**3-8" DuraFlex Vertical Cap and Top Plate no longer available
New 3-8" DuraFlex Removable Vertical Cap and Top Plate / Storm Collar
offered instead**

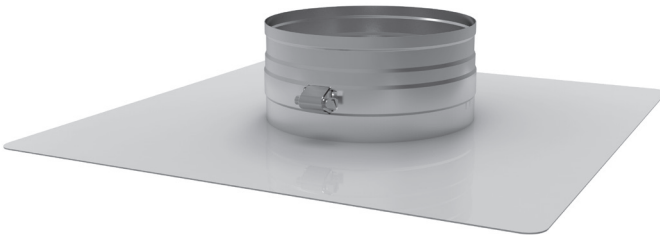
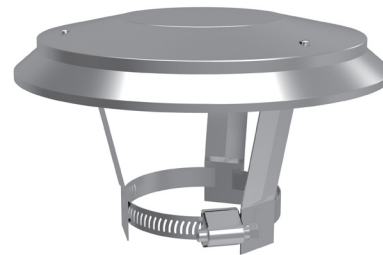
DuraFlex SS storm collar previously included with Vertical Cap will now come welded to Top Plate.
As a result, Top Plate and Storm Collar (DFS-TPSC) and Removable Vertical Cap (DFS-VCRC) finished goods will be offered.

Welding the Storm Collar to the Top Plate ensures that the Storm Collar and Removable Cap stay fastened to the Top plate. Previously, the Vertical Cap and Storm Collar were connected to the assembly with hose clamp connection to chimney flex.

The original Top Plate (DFS-TP) and Vertical Cap (DFS-VC) will be discontinued and no longer offered for 3-8" sizes.
10" and 12" Top Plate (DFS-TP) and Vertical Cap (DFS-VC) will remain unchanged at this time.
